**OVEN MOUNTAIN PUMPED HYDRO ENERGY STORAGE**

Submissions Report

## Submissions Report

E230869C Submissions Report1

Oven Mountain Pumped Hydro Energy Storage Project  
 Submissions Report  
 OMPS Pty Ltd  
 Figure 5.1

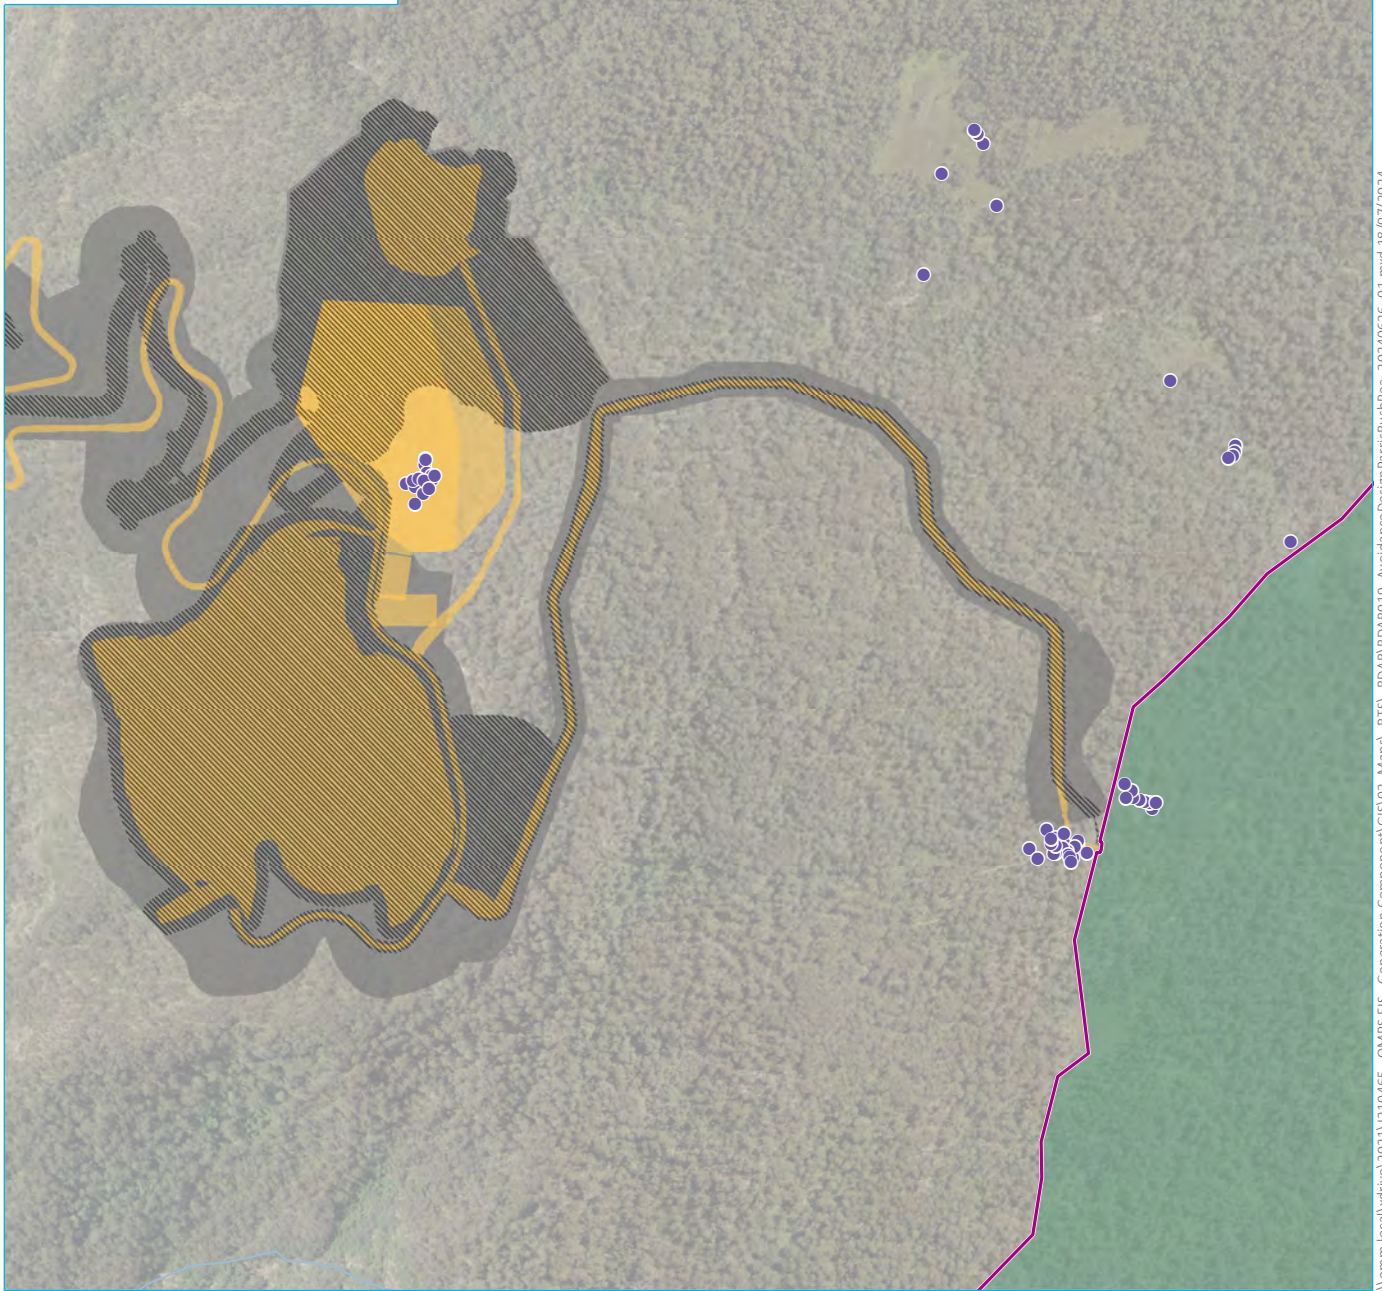
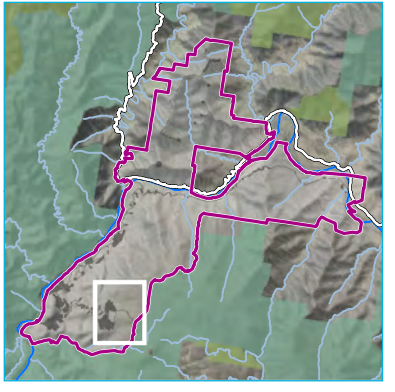
- Along the UDAR to avoid critical habitat for the Brush-tailed rock-wallaby (shown in Figure 5.1). This includes the complete removal of a north-south road linking the Main Access Road and the UDAR, an area which recorded a population of Brush-tailed rock-wallaby and associated denning habitat.
- Upper PSE and Carrai access area to avoid individuals and microhabitat for *Pultenaea rubescens* (shown in Figure 5.2). No flexibility is provided to the design in these areas to ensure direct impacts are avoided.

**Figure 5.3 Indicative OSOM vehicle (EIS) specifications**

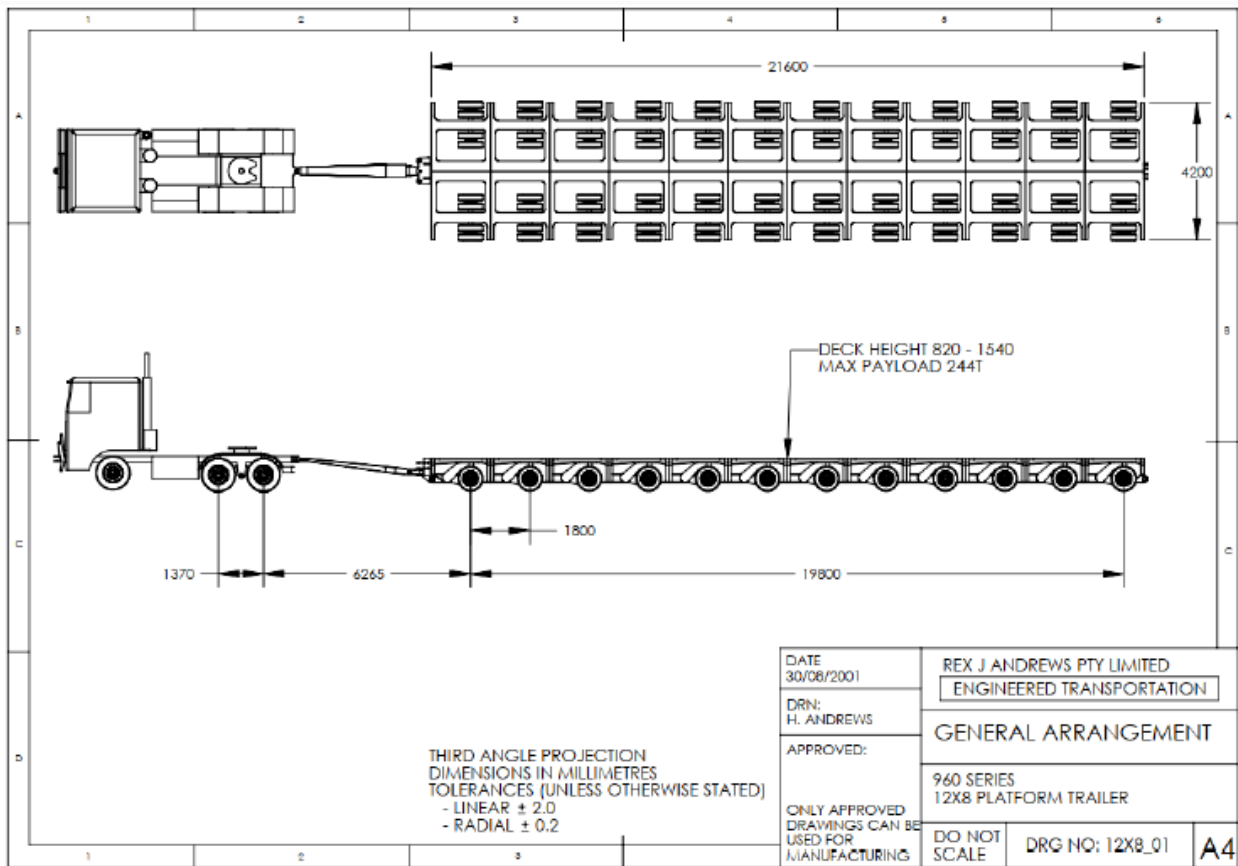
The initial OSOM report provided with the EIS was compiled by Rex J Andrews (2022) was based on a conservative assumption around a design vehicle (shown in Figure 5.3). The selected design vehicle was utilised to complete swept and tracking path analysis as part the OSOM report, as this was the information available at the time.

The proponent has since engaged an Original Equipment Manufacturer (OEM) to provide an updated list of OSOM components and sizes. This provides more certainty around availability in the market of fit for purpose vehicles and equipment for this project. Based on OSOM load specifications by the OEM on this information, a design vehicle with a smaller swept and tracking path has been selected.
